APPLICATION NO.	FILING DATE	FIRST NAMED INVENTOR	ATTORNEY DOCKET NO.	CONFIRMATION NO.
09/753,352	12/29/2000	Bruce E. McGarvey	257/262	9728

Office Action Summary

DETAILED ACTION

Examiner's Figure

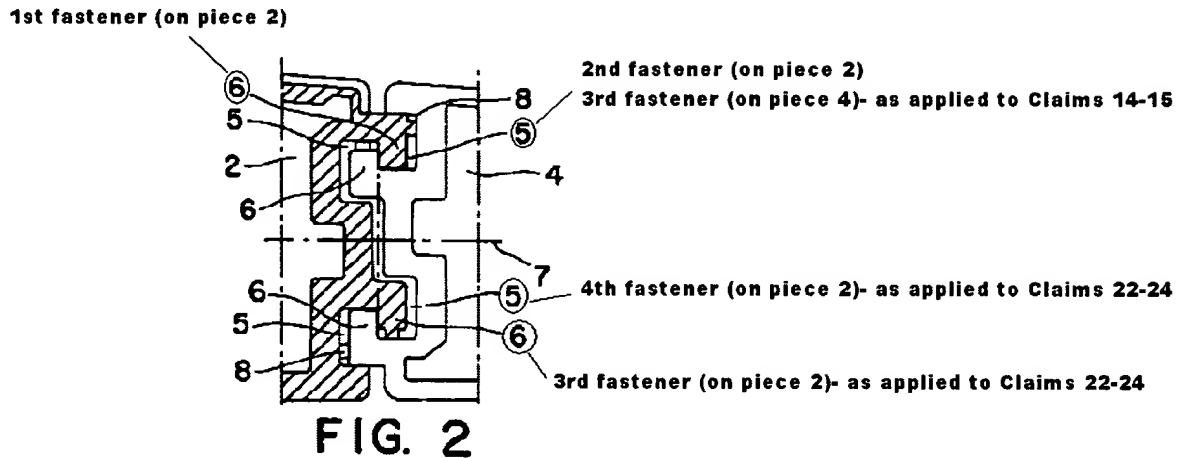
3. Maier-Hunke describes a system for organizing one or more elongated objects having a reusable first fastener (6), adapted to extend along all of the length of a first elongated object (2) and capable of coupling the first elongated object to a second elongated object (4), and a second fastener (5), along all of the length of a first elongated object (2) and capable of coupling the first elongated object to a second elongated object (1), where the first fastener and second fastener have substantially complimentary shapes (see Figures 1-2, and Column 1-2 of Maier Hunke and Examiner's Figure, below).

7. Maier-Hunke further describes third fastener (5 – see Examiner's Figure), a female component, adapted to extend along the second elongated object (4) and capable of coupling the second elongated object to the first elongated object (2). The first and third fasteners are

8. Maier-Hunke further describes a third fastener (6 – see Examiner's Figure) integrated with the first elongated object having similar shape to the first fastener.

9. Maier-Hunke further describes a fourth fastener (5 – see Examiner's Figure) integrated with the second elongated object having similar shape to the fourth fastener.
